ADDRESS: 1830 RITTENHOUSE SQ, UNIT 6A

Proposal: Replace Windows

Review Requested: Final Approval

Staff Contact: Randal Baron, Randal.Baron@phila.gov, 215-686-7660

#1

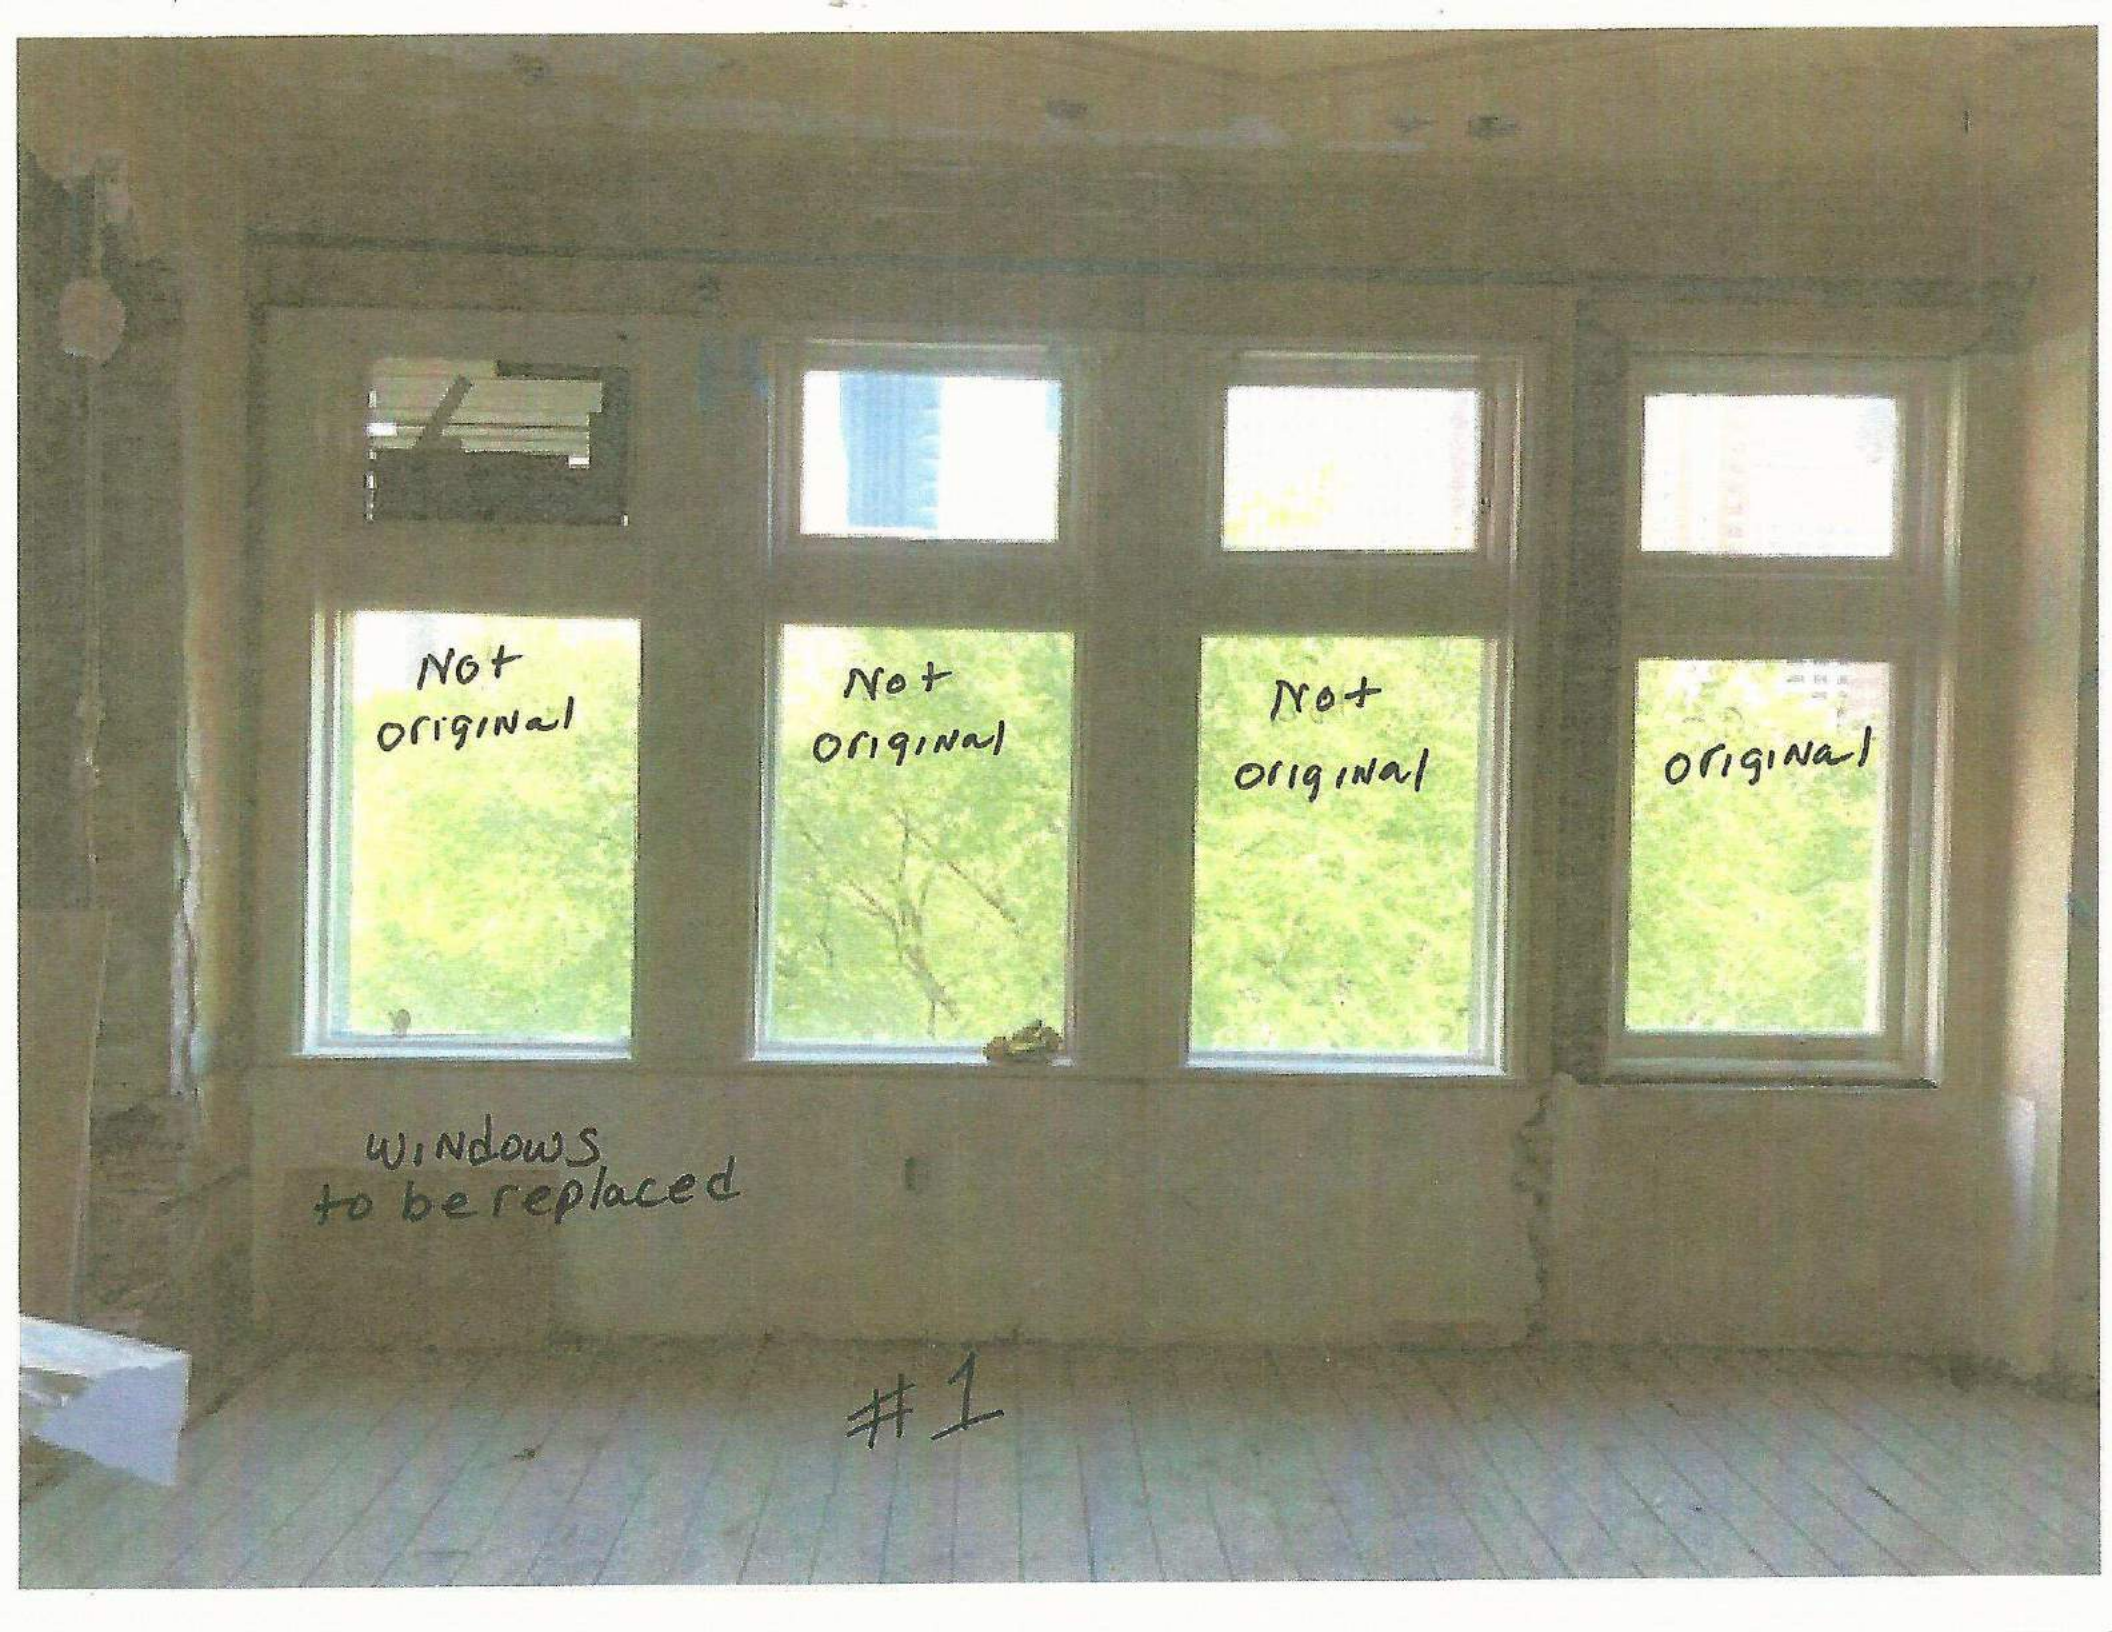
A unit owner proposes to replace windows in this condominium building. The owner proposes to remove eight historic windows (F) with the large wood mullions on the front façade and install picture windows without mullions. In 2002, the Historical Commission approved the same project for the same owner for a unit on the 15th floor. The owner is now moving from that unit on the 15th floor to the unit in question on the 6th floor and would like to recreate the window configuration. During the 2002 review, the owner pointed out that several units in the building have picture windows without the wood mullions. Those units may have been modified before designation or without the Historical Commission's approval. In 2002, both the staff and the Architectural Committee recommended against removal of the historic windows, contending that the project failed to meet the Secretary of the Interior's Standards. However, the Historical Commission approved the alteration. This time, the windows slated for replacement are more visible from the street because they are on a lower floor. The application also proposes to remove several vinyl and metal windows on the side facades of the building and replace them with one-over-one wood windows. The removal of the metal window (G) in wood on the side façade may not meet the Standards because the metal window is likely original.

- *Standard 2: The historic character of a property shall be retained and preserved. The removal of materials or alterations of features and spaces that characterize a property shall be avoided.*
 - The project would remove character-defining features, the distinctive original front windows.
- *Standard 6: Deteriorated historic features will be repaired rather than replaced. Where the severity of deterioration requires replacement of a distinctive feature, the new feature will match the old in design, color, texture and, where possible, materials.*
 - The proposed windows will not match the historic windows in design.

STAFF RECOMMENDATION: Approval of the restoration of most side windows; denial of the removal and replacement of original front windows, pursuant to Standards 2, and 6.
